# Final Drainage Report

## The Townhomes at Bradley Crossroads

Project No. 61093

PCD File No. PPR1846

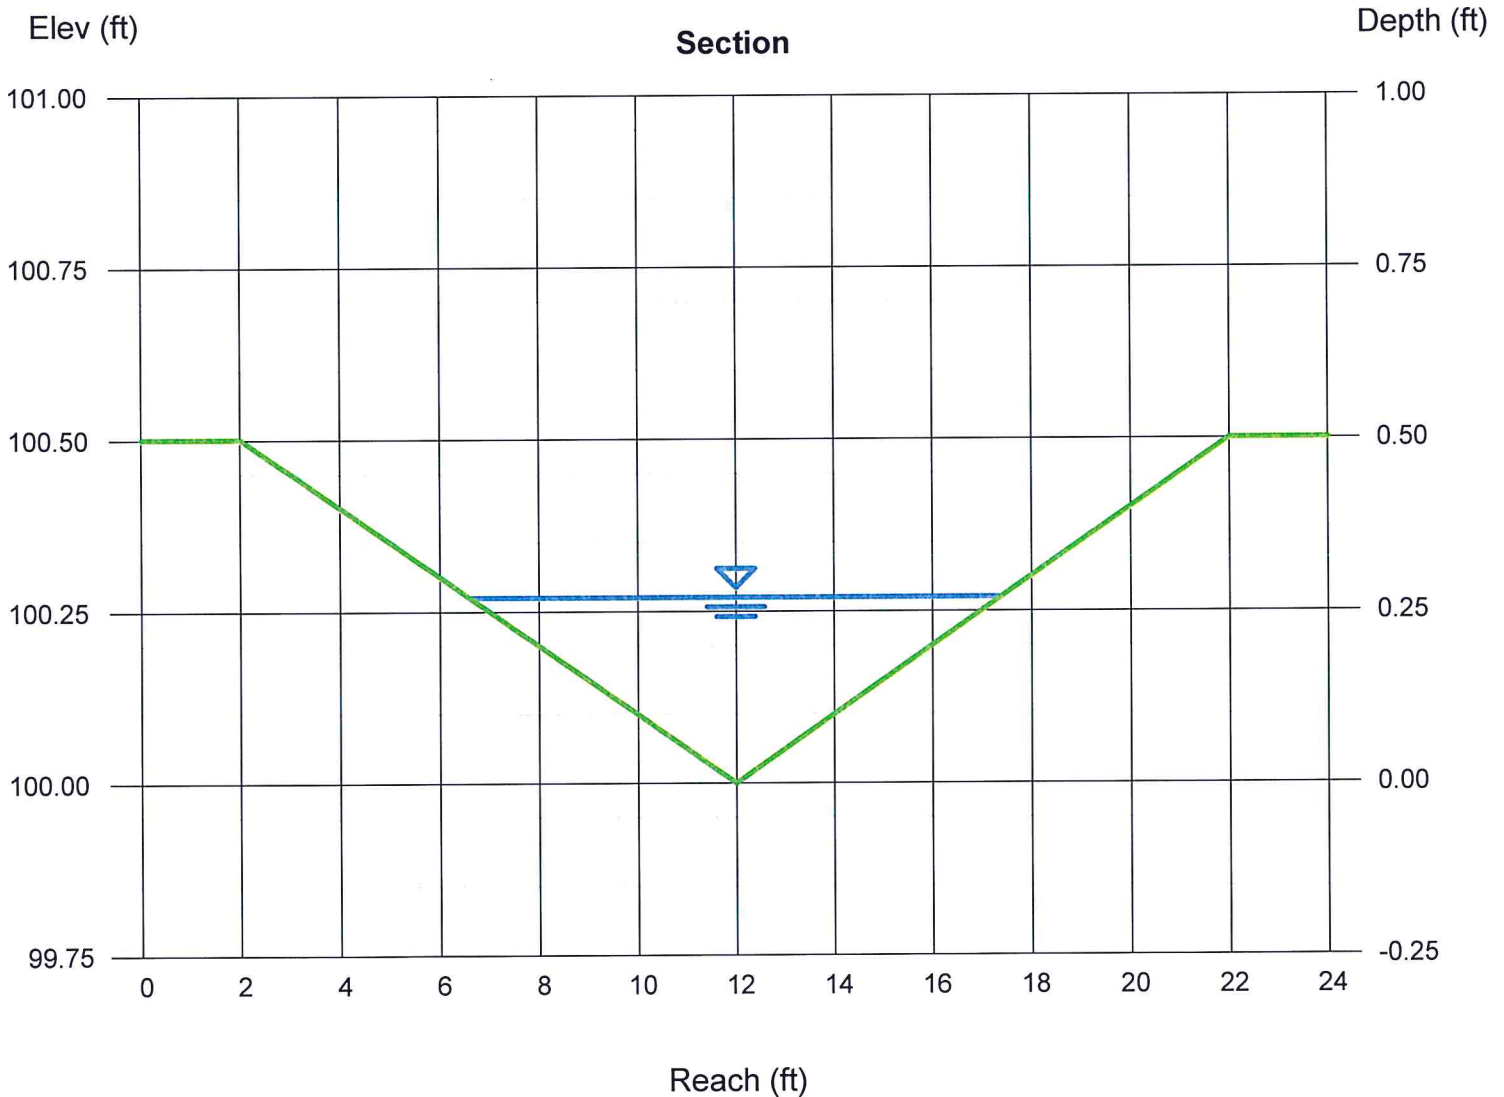
revise name as this is not a trapezoidal section. Typical

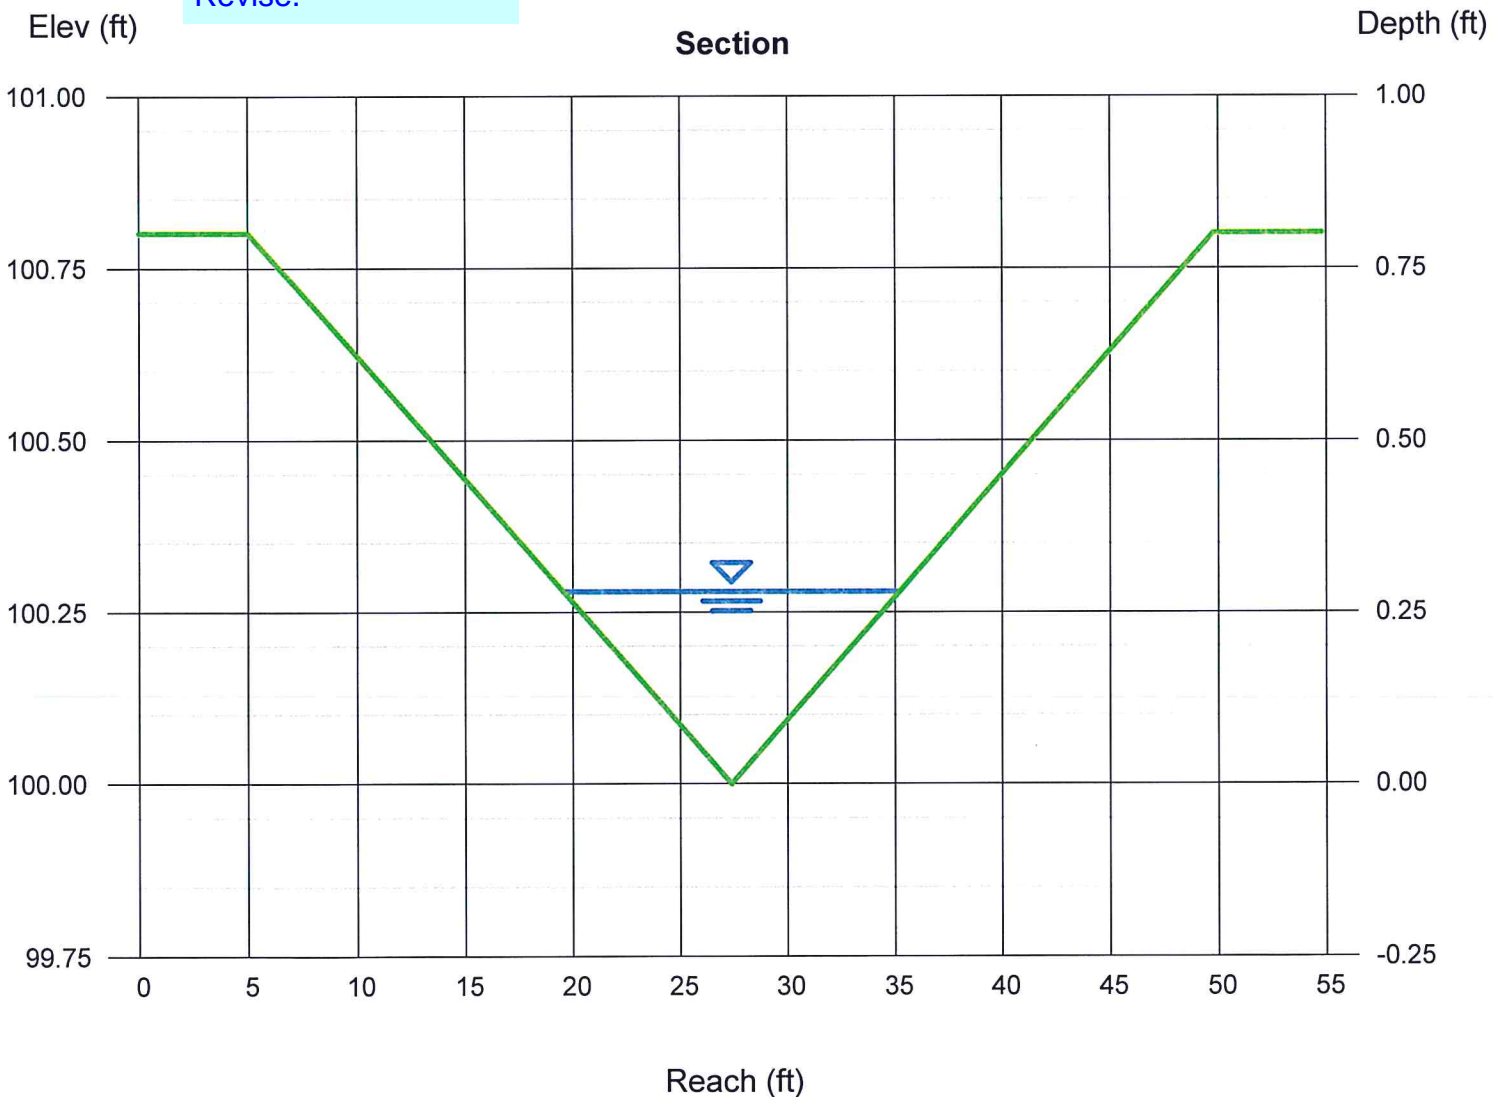
It appears this is design point 4. Revise.

MVE PROJECT 61093  
MVE DRAWING -DRAIN-PP

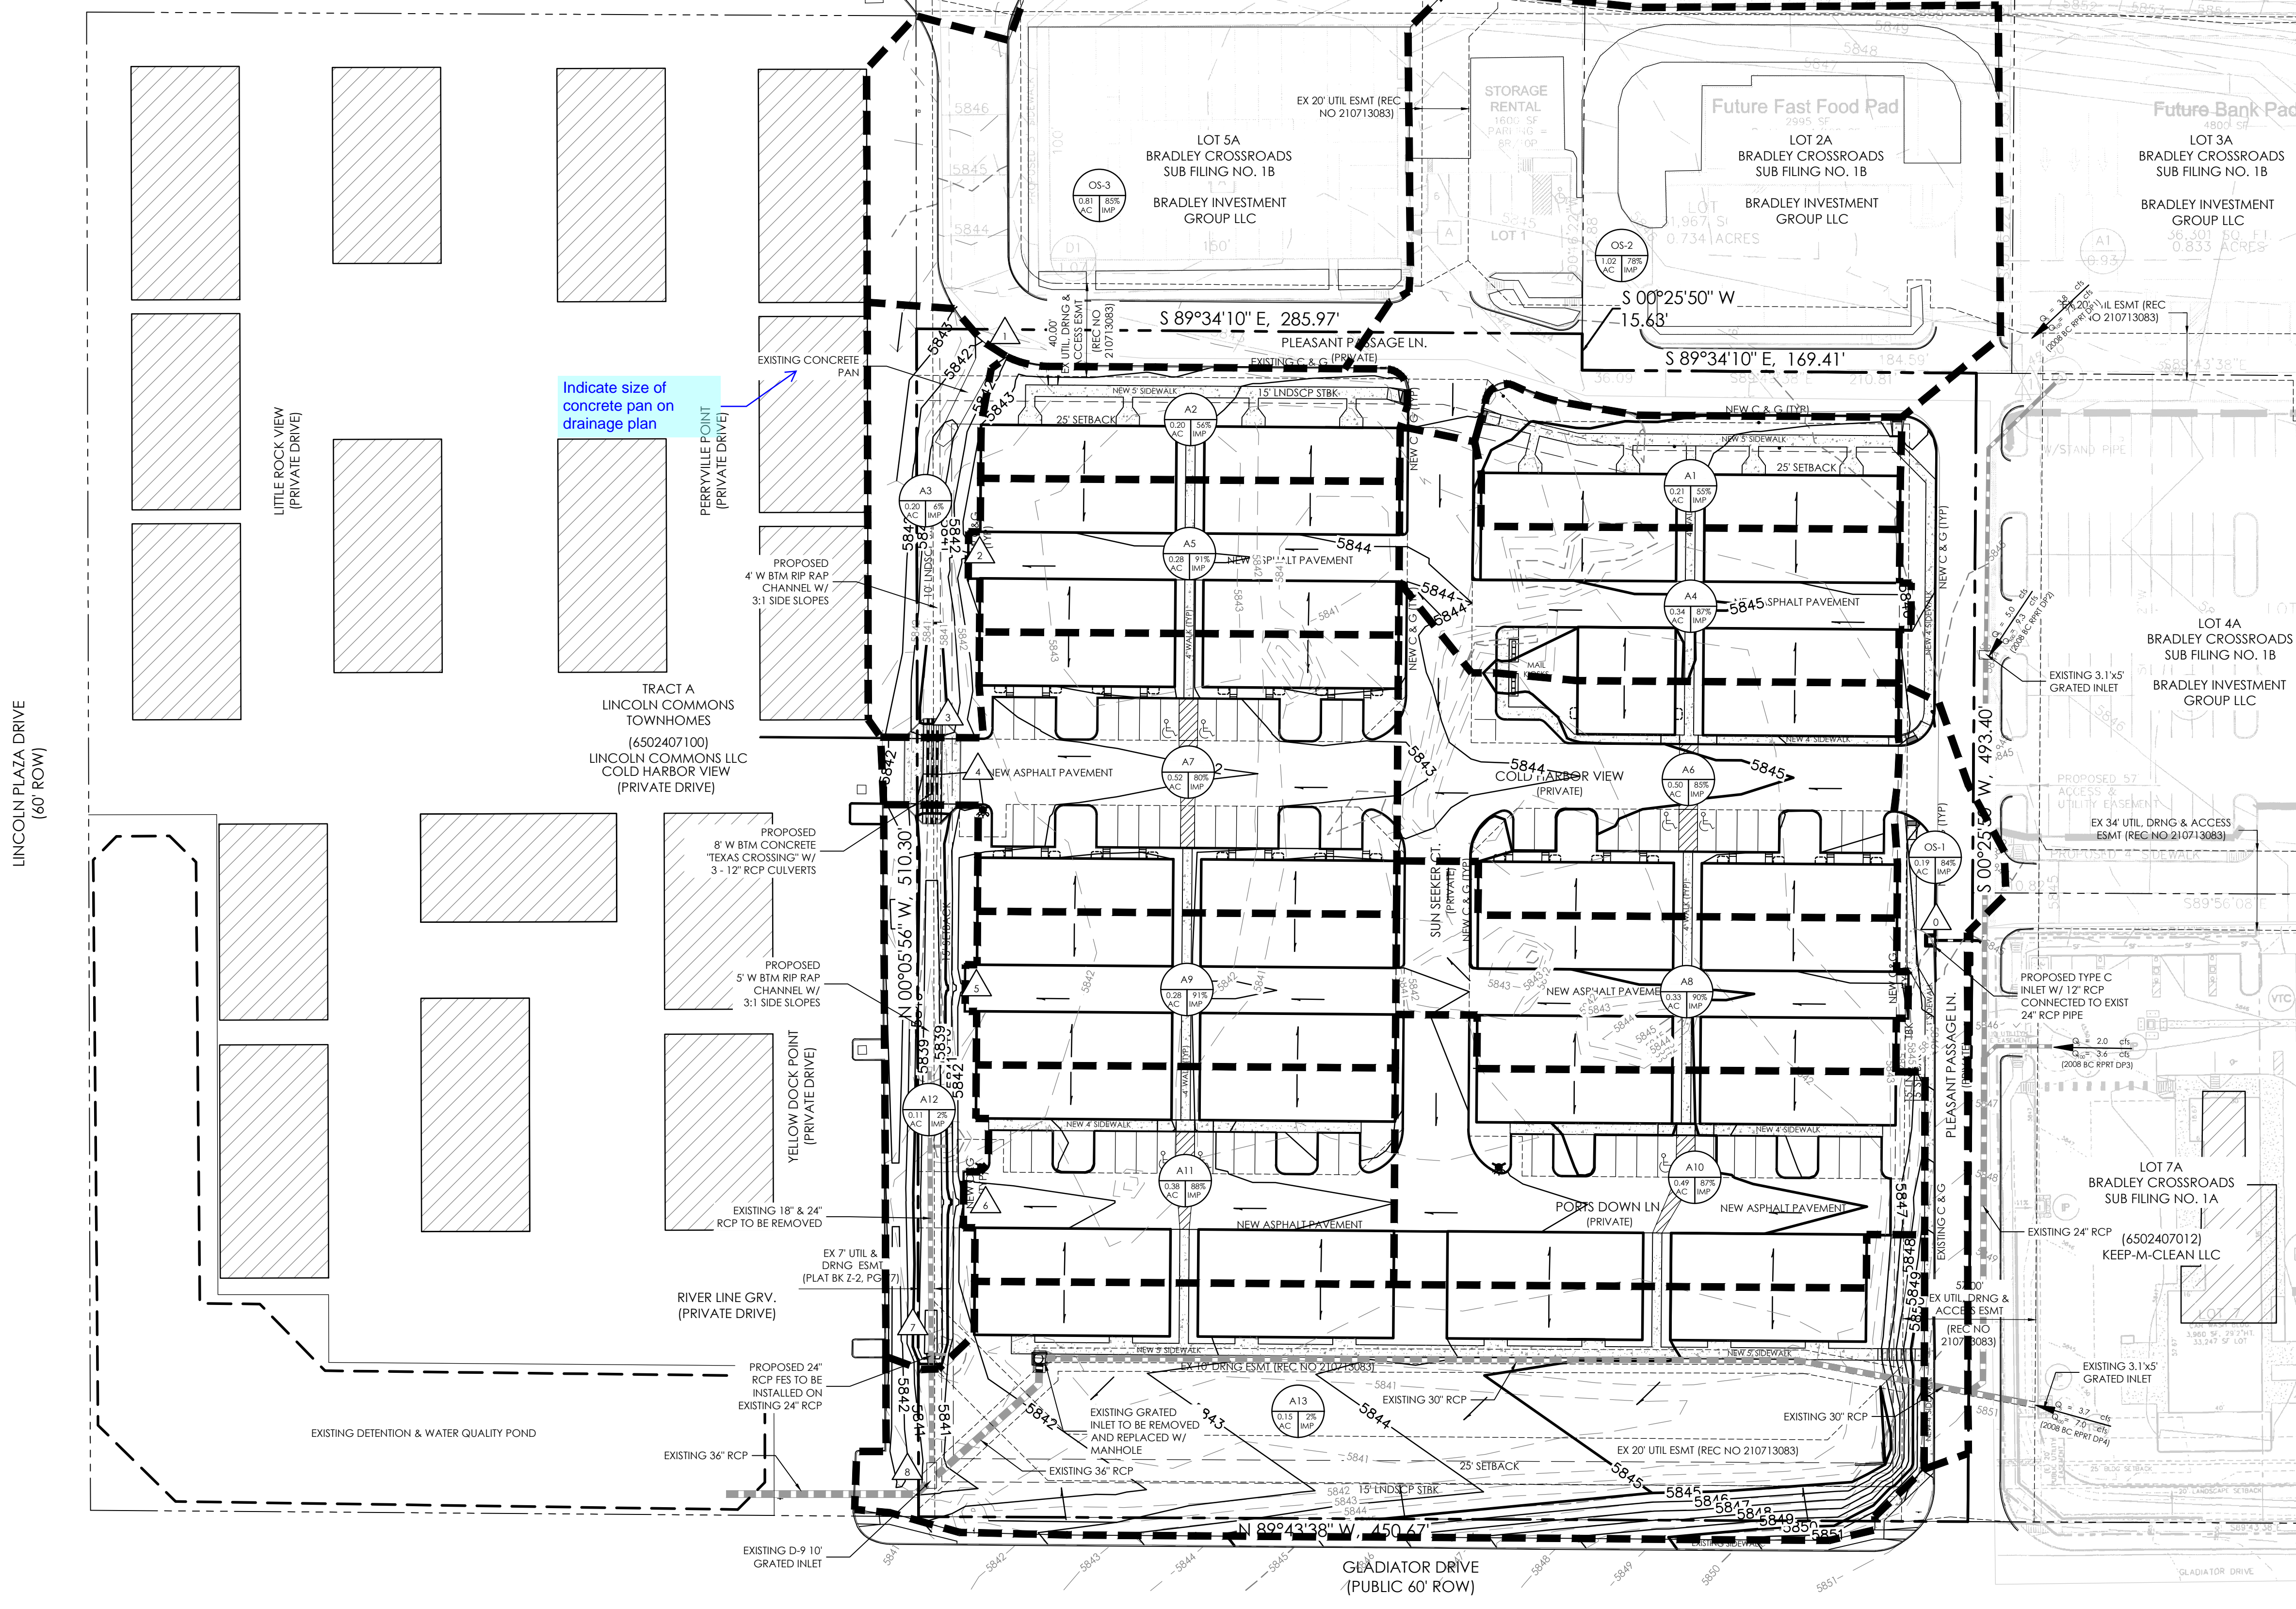
Indicate size of concrete pan on drainage plan
